Minutes of a meeting of the Planning Committee of Aldington and Bonnington Parish Council held on Monday 11th July 2022 at 7.00 pm in Aldington Village Hall, Roman Road, Aldington.

111. Planning application 22/00795/AS - Pumping Station, Wheatfields, Aldington – Retrospective application for a Pumping Station, including associated cabinets, lighting, hard and soft landscaping and associated ancillary works.

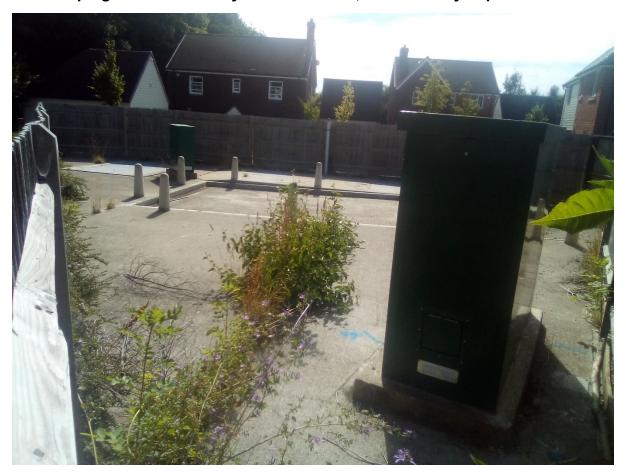
Paragraph 5.4 of the planning statement quotes the existing kerbstones outside of the fenceline as being confirmed to be retained through the Enforcement Notice. This appears to be at odds with the Landscape GA plan (drawing no. 29710 RGLD 01 REV B) which shows an area of planting behind the cabinet that is on the west side of this site, near the bollards. The following photograph

shows how close the cabinet is to the existing fence and that the Overall Landscaping GA was not only not adhered to, but currently impossible.

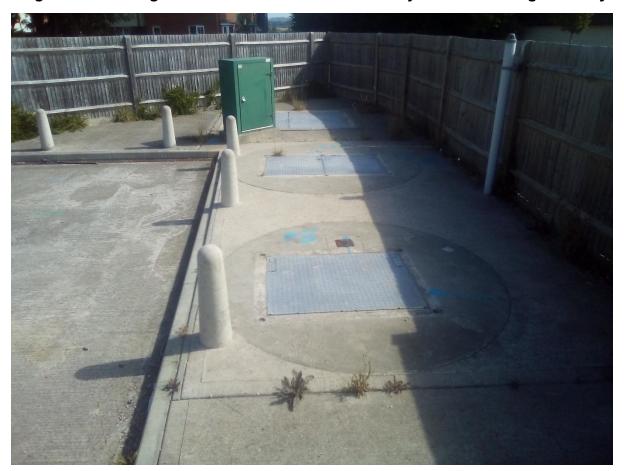
The Landscape GA plan and the Proposed site plan show shrub planting along the Eastern side of the site where the vent pipe is situated. The photograph below shows that the concrete around the manhole covers is round, which would appear to imply that the structure below would prevent this area being reduced in size

On this side of the development shrub planting, or extension of the hedge on the northern side, is necessary to retain residents visual amenity. We would like to suggest that the tarmacked ProW adjacent to the site could be reduced widthways to increase available space for planting. Its present width is excessive and has led to retro-fitting of bollards to deter vehicles using it as a cut-through. A reduced width would make it more obvious that this is a footpath and leave ample room for pedestrians and cyclists, as well as visual enhancement of the boundary through creation of an area that is sustainable for planting. Planting should be at least as high as the green cabinets within the site.

The current position of the vent pipe supported by the fence is too close to the nearest property and impacts pedestrians using the PRoW, so consideration should be given to relocation of this pipe to the far side of the site furthest away

from any property. In its current location, secured to the fence, and at fence height the resulting odours affect the users of the adjacent Public Right of Way.
